ADDENDUM NUMBER 2

Twin Falls Resort State Park
Structural Beam and Kitchen Floor Repair
RFQ # DNRB13028

Dated: October 4, 2012

PROJECT TITLE: ALUMINUM STOREFRONT DETAILS
 PROJECT: TWIN FALLS' LODGE MULLENS, WEST VIRGINIA
 DRAWING NO. 1051.00
 FILE NAME
 SHEET NO. SK-2

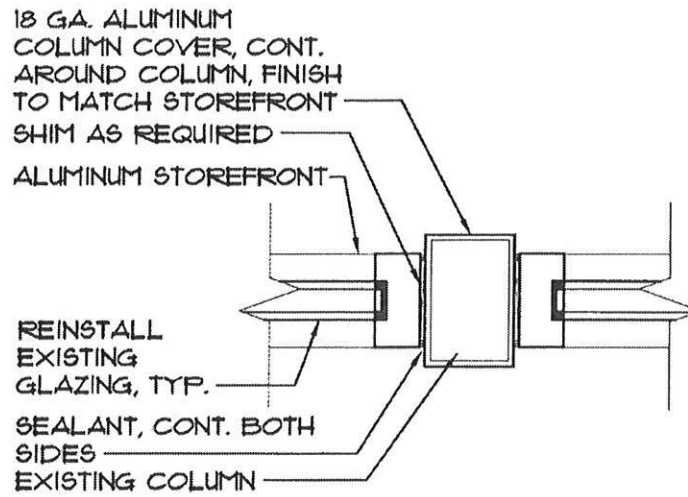
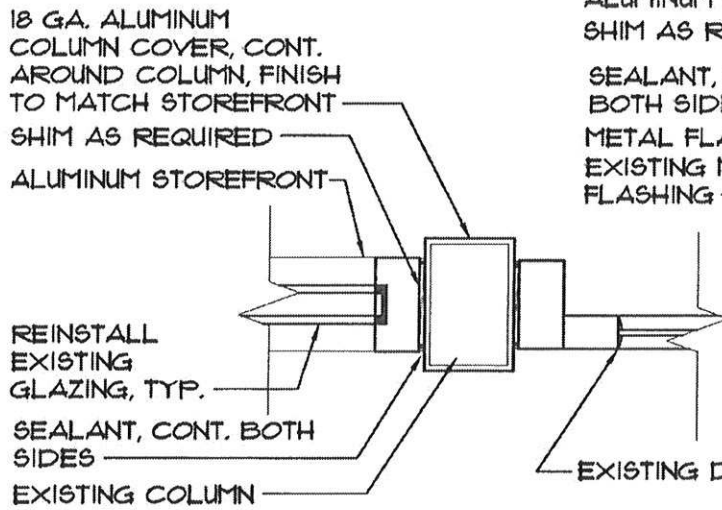
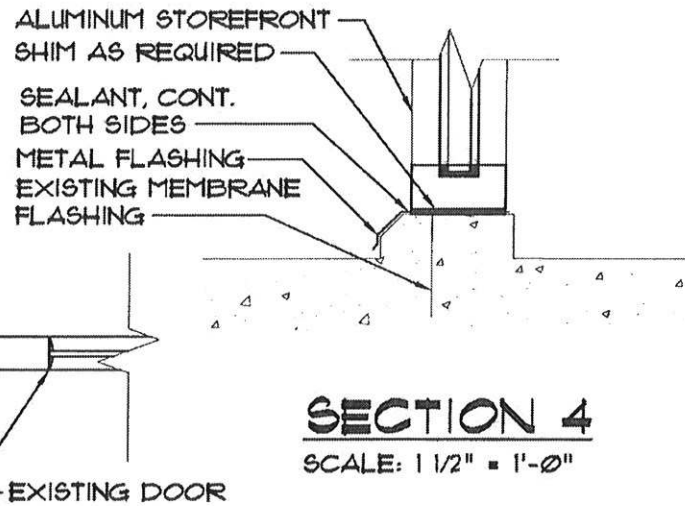
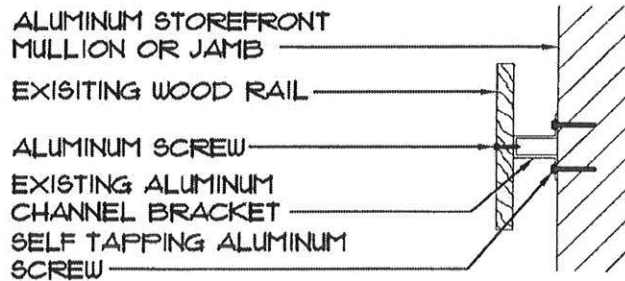
The drawings request the storefront system to be detached and reset in order to achieve the installation of the new structural support. The existing storefront is an Old Kawneer Nu-Core System and detaching and resetting is not possible due to the fastening procedures of this system. *See attached sketches SK-1 and SK-2 to more fully describe the work to replace the store front. We will plan to re-use the glazing (glass) and doors/hardware and wood rail on the inside.*

Question: Should the Bidders bid to install a new storefront system due to the existing storefront systems fabrication not allowing the system to be salvageable? *Yes, per the information included in this addendum.*

Question: Is YKK and acceptable manufacturer for a new storefront system? *Yes, as long as the storefront system matched the color, profile, etc as the existing one.*

Question: Should the Architect provide specifications for storefront entrances, glazing and hardware? *Information is included with this addendum.*
